Meeting Agenda

Historic Zoning Commission

Monday, September 11, 2023

NOTE: DARKEST ROOF NOTATION REPRESENTS AREA OF ROOF TO BE RECONSTRUCTED BACK TO ORIGINAL W/ SAME EXACT PITCH AND HEIGHT WITH ORIGINAL STYLE & COLOR COMPOSITION SHINGLES.

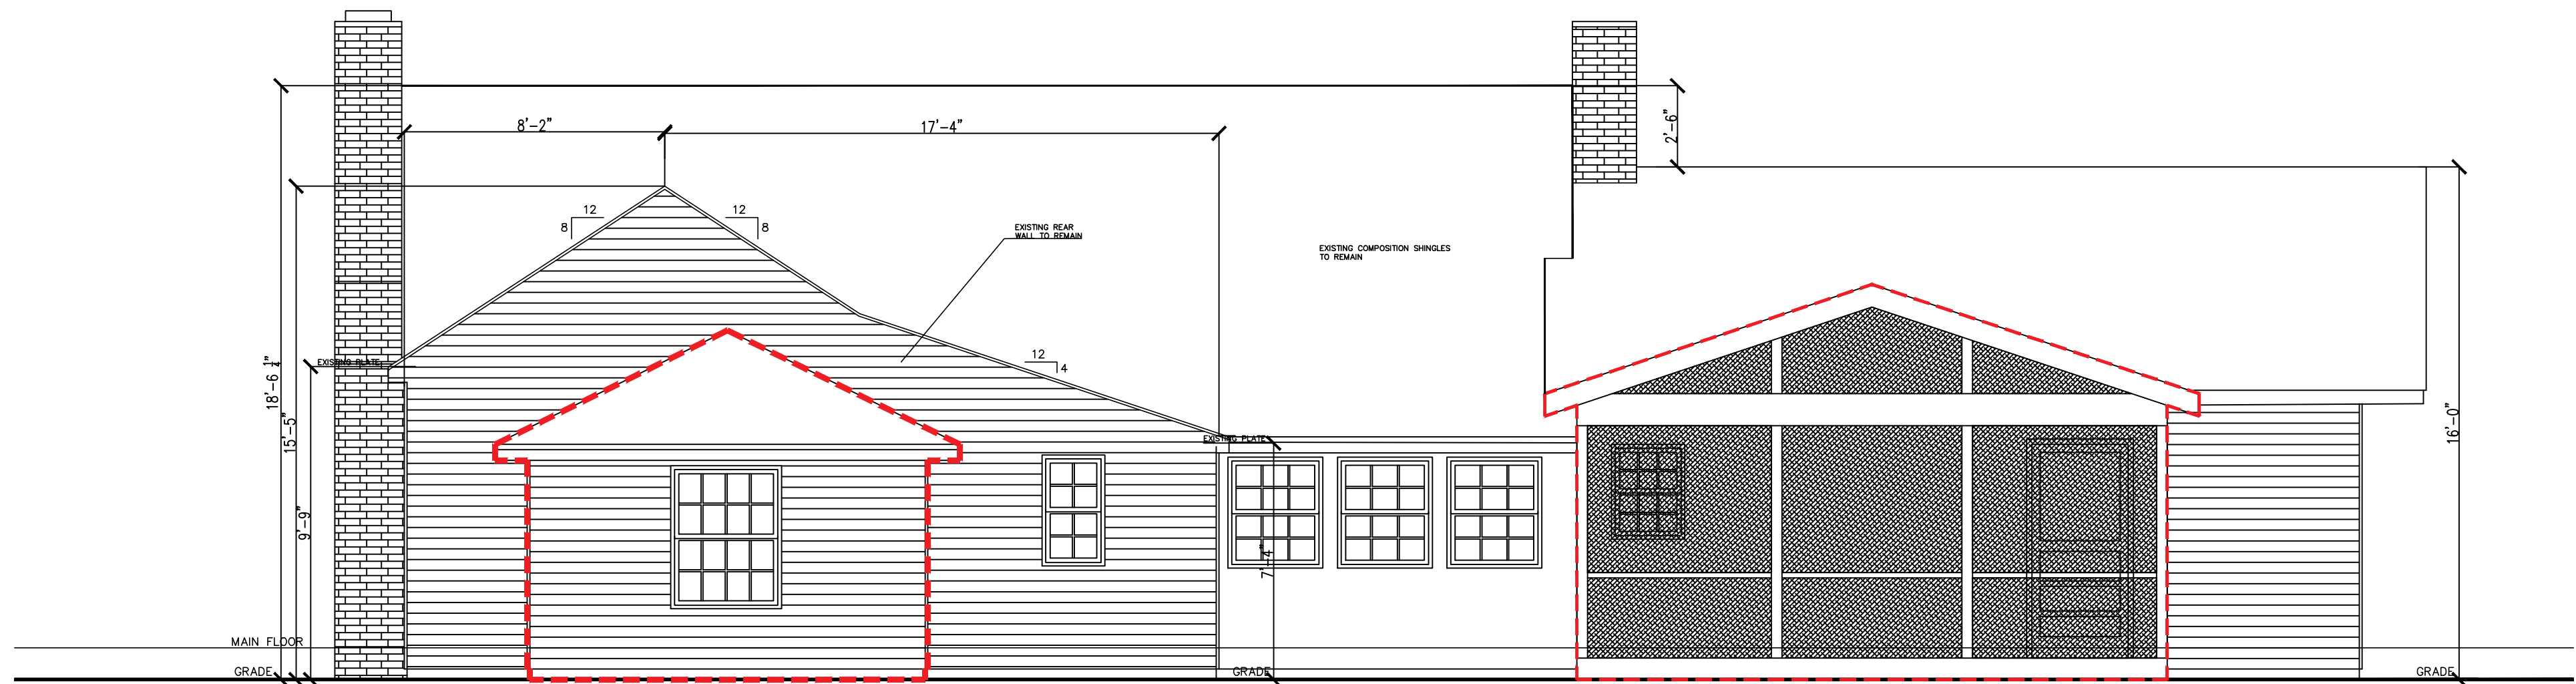
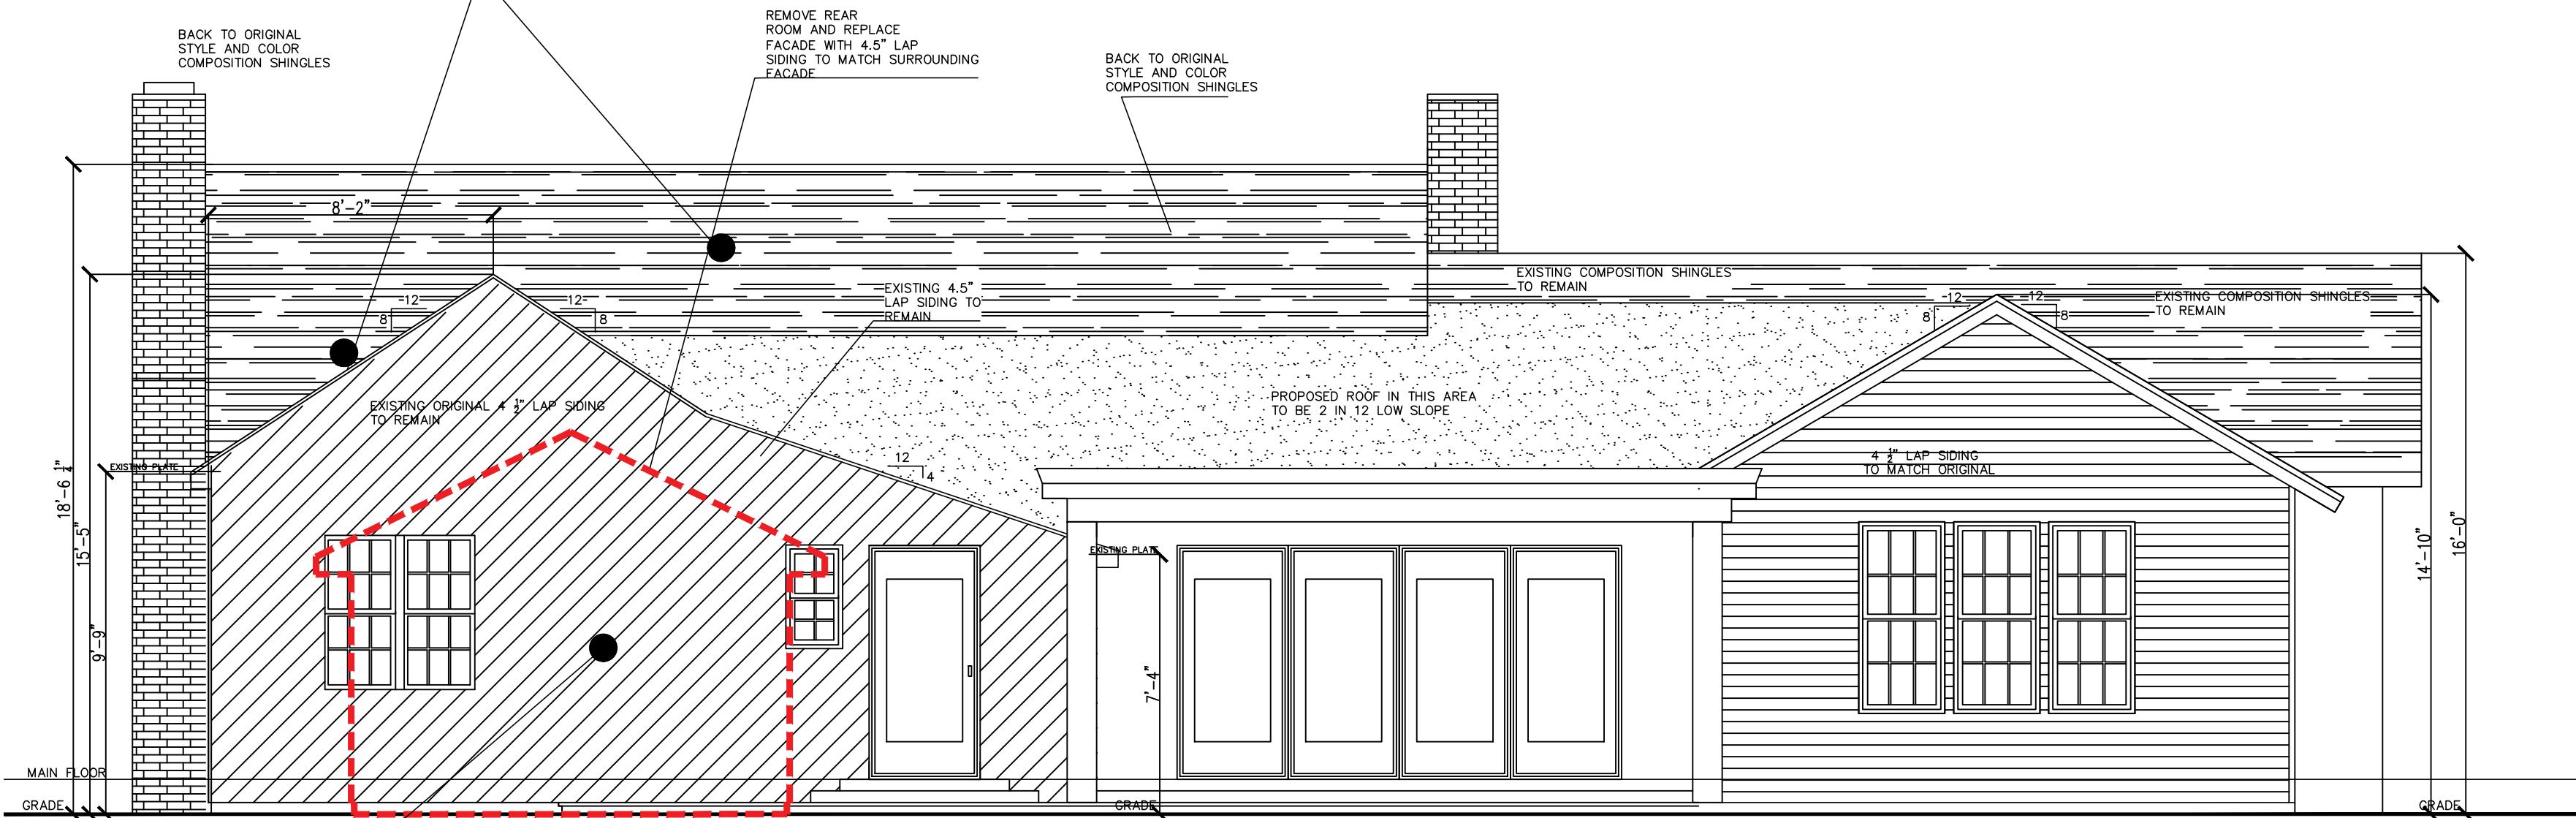
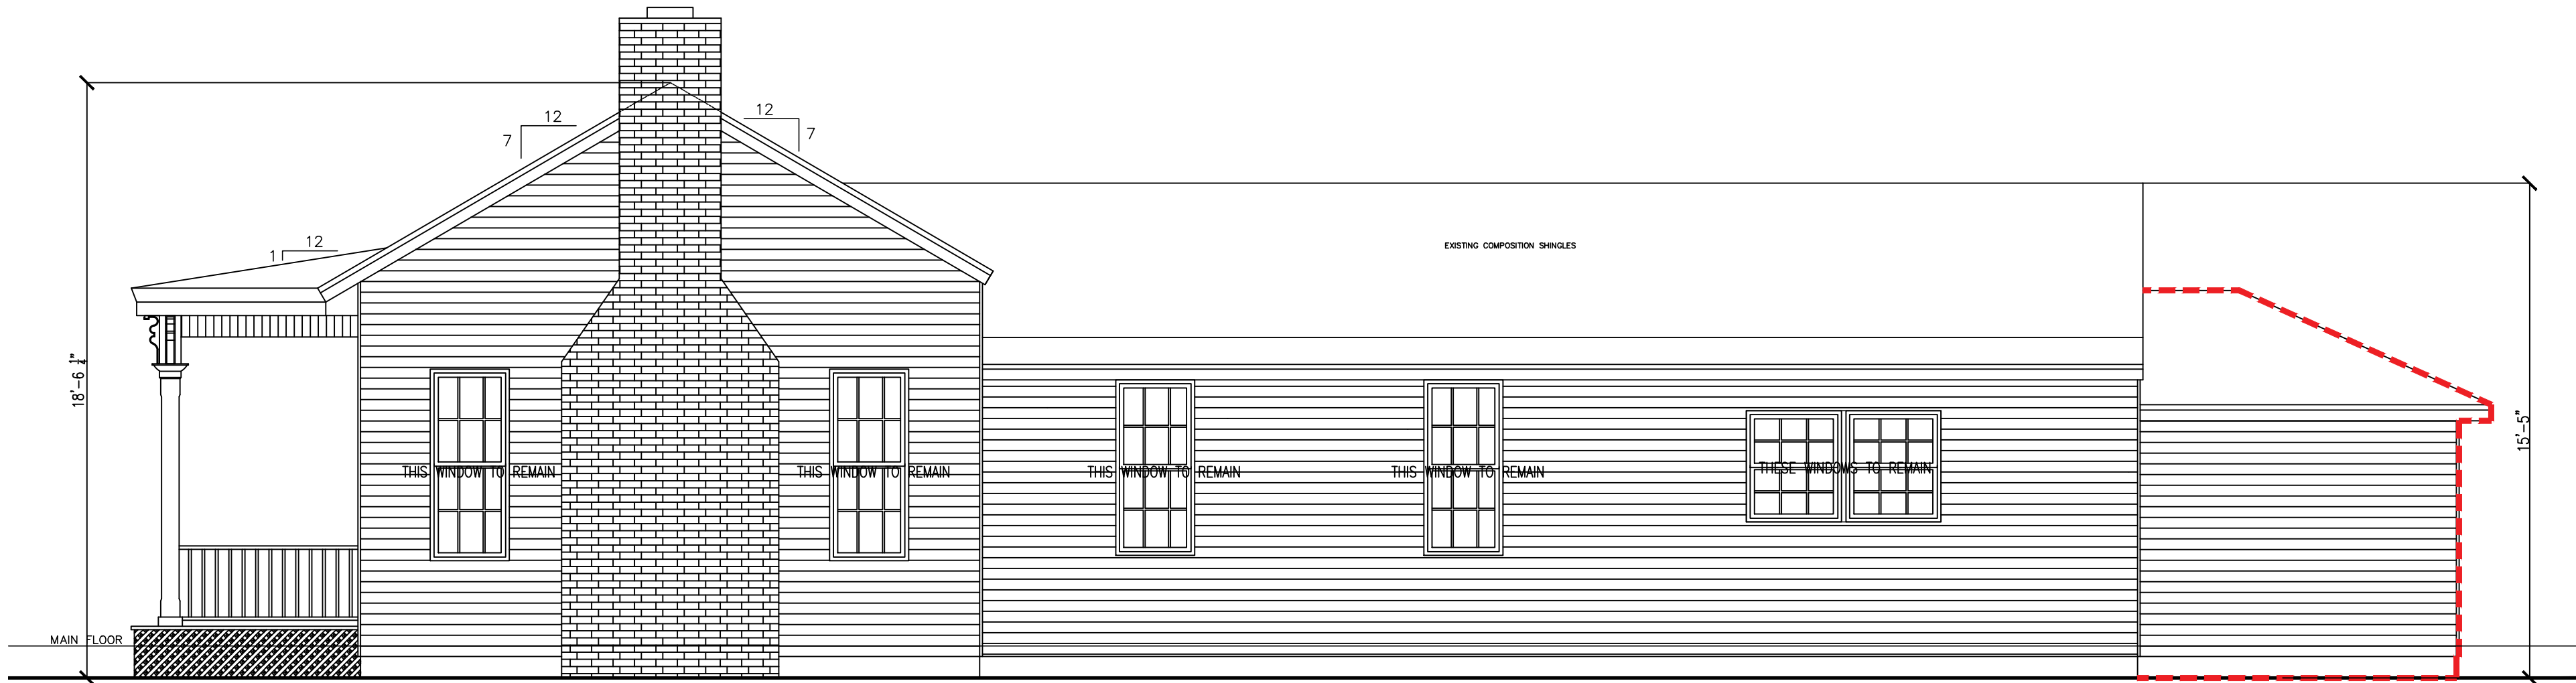
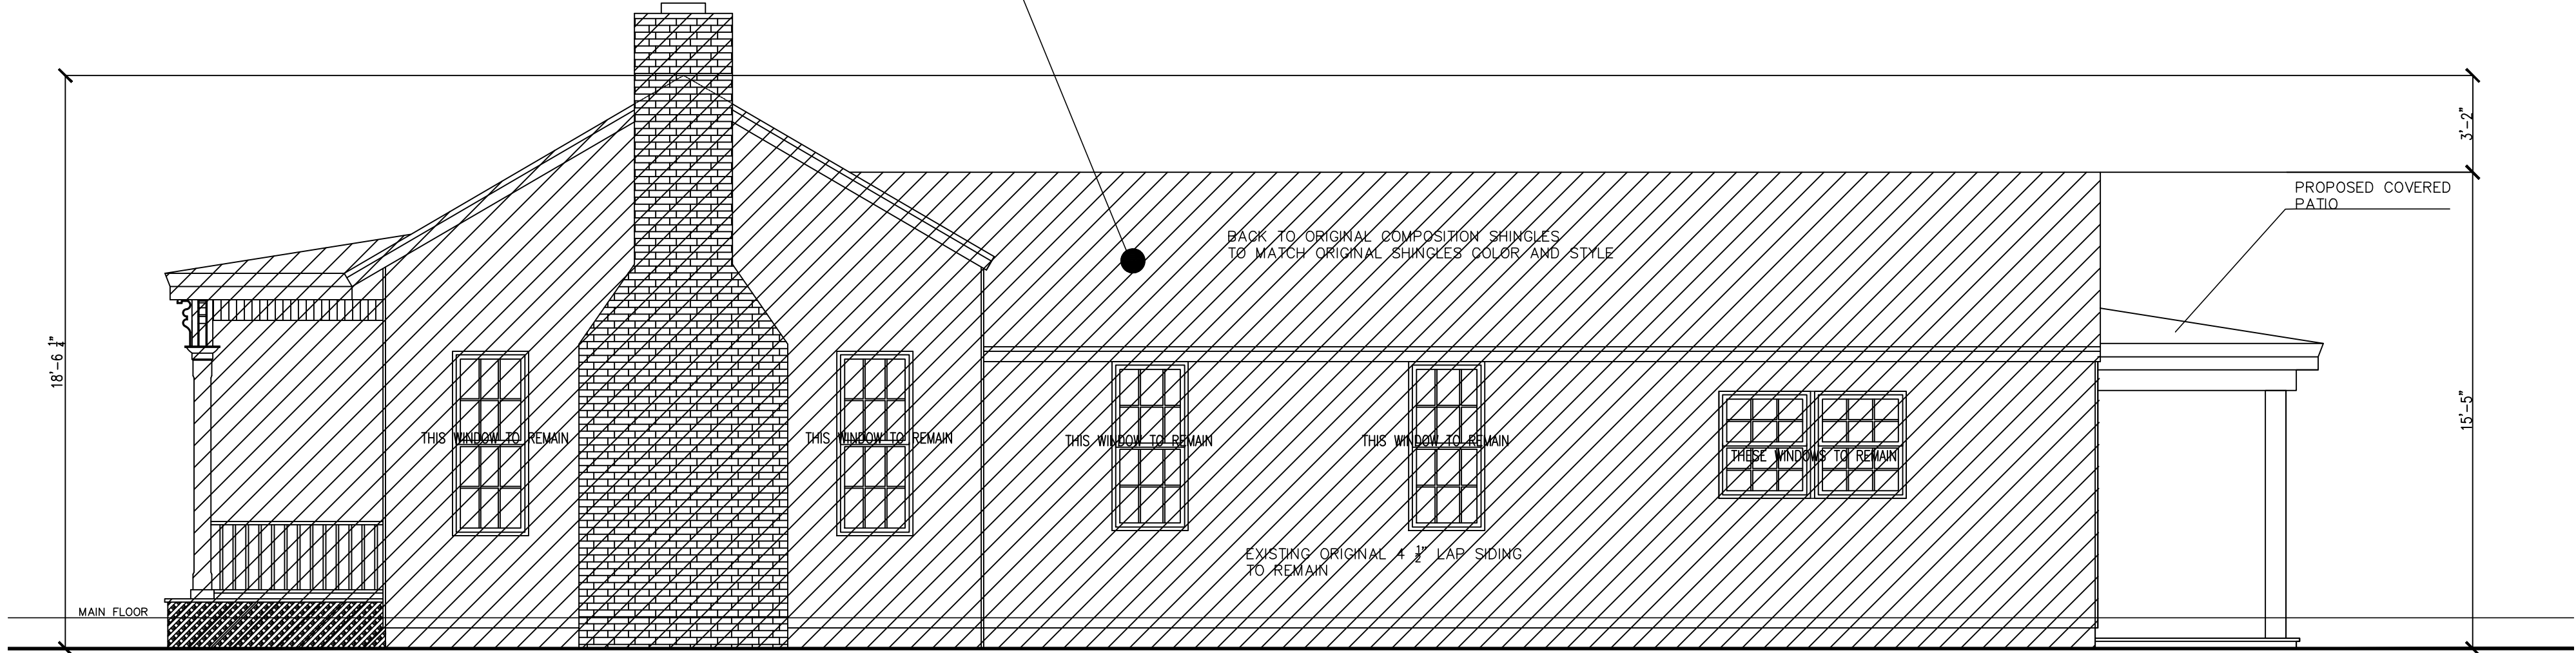
For alteration to roofs on historic residential buildings, the City of Franklin Historic District Design Guidelines recommend to "Preserve historic roof forms and materials. Roofing sections on main and other visible facades should remain unaltered," and that "If localized damage occurs, replace the damaged materials only and entire roof and truss replacement on historic structures is not recommended; however, given the circumstances and the current state of the dwelling, in this instance the application can be supported. The roof must be reconstructed to match what was there previously using materials that match the

original. The proposal before the commission includes measurements for the roof. The Building & Neighborhood Services Department field verified the height measurements for the roof ridgeline of the original historic building using ghost measurements on the chimney. The historic side addition roof ridgeline height was also field verified and those measurements on the proposed plans are accurate. It is not possible to field verify the height on the historic rear addition; however, the proposed plans match the existing wall heights given the location of the existing windows on the right elevation and previous photographs.

1. The 6-foot added addition on the right, rear historic addition must be removed, so that the plan matches exactly what was approved by this COA.
2. The roof must be reconstructed to match the heights, pitches and exterior materials previously existing, according to all measurements and scaled dimensions per the plans approved by this COA.

5. The existing lap siding reveal and width must be utilized on the new lap siding. No existing wood lap siding shall be removed without Preservation Planner or Historic Zoning Commission approval.
